Group:	17-Intake & Exhaust
Bulletin No.:	14-002
Issue Date:	3/28/2014

# SERVICE INFORMATION BULLETIN

## **CORRECTION OF WORKSHOP MANUAL FOR HINO 155, 195,155h, 195h (REVISION OF TROUBLESHOOTING PROCEDURE FOR THE DTC P0045 & P259E)**

Inspection procedure of the DTC/P0045 for 13MY model and DTC/P259E for 14 MY model were revised. (Add and change the inspection procedure for checking the turbocharger actuator wiping function failure due to foreign substances entering around the link rod.)

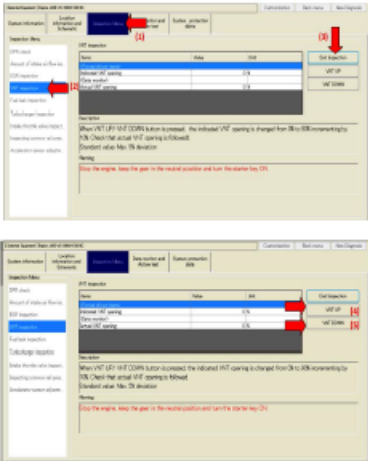
ADD

<b>3</b>	<b>Check the turbocharger external appearance</b>
<ol style="list-style-type: none"> <li>1. Remove EGR cooler for checking the turbocharger.</li> <li>2. Check the turbocharger external appearance and make sure no foreign substances are trapped around the link. <b>Standard: Foreign substances are trapped around the link.</b></li> </ol>	
 <p style="text-align: right; font-size: small;">SHTS021270300047</p>	
<p><b>NO</b> → Proceed to the step 4.</p>	
<p><b>YES</b></p>	
<p>Remove foreign substance, and proceed to the step 6.</p>

<b>3</b>	<b>Check the turbocharger external appearance</b>								
<ol style="list-style-type: none"> <li>1. Remove EGR cooler for checking the turbocharger.</li> <li>2. Check the turbocharger external appearance and make sure no foreign substances are trapped around the link.</li> </ol>

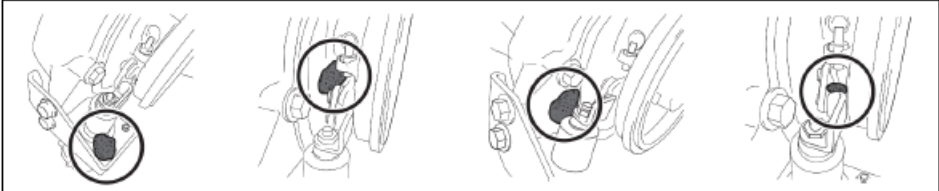
CHANGE

<small>SHT8021270301118</small>									
<table border="1" style="width: 100%;"> <tr> <td colspan="2" style="text-align: center;">Was any failure found?</td> </tr> <tr> <td style="text-align: center; width: 50%;"> <table border="1" style="width: 100%;"> <tr> <td style="text-align: center;">YES</td> </tr> </table> </td> <td style="text-align: center; width: 50%;"> <table border="1" style="width: 100%;"> <tr> <td style="text-align: center;">NO</td> </tr> </table> </td> </tr> <tr> <td style="text-align: center;">Remove foreign substance, and go to step 4.</td> <td style="text-align: center;">Go to step 4.</td> </tr> </table>		Was any failure found?		<table border="1" style="width: 100%;"> <tr> <td style="text-align: center;">YES</td> </tr> </table>	YES	<table border="1" style="width: 100%;"> <tr> <td style="text-align: center;">NO</td> </tr> </table>	NO	Remove foreign substance, and go to step 4.	Go to step 4.
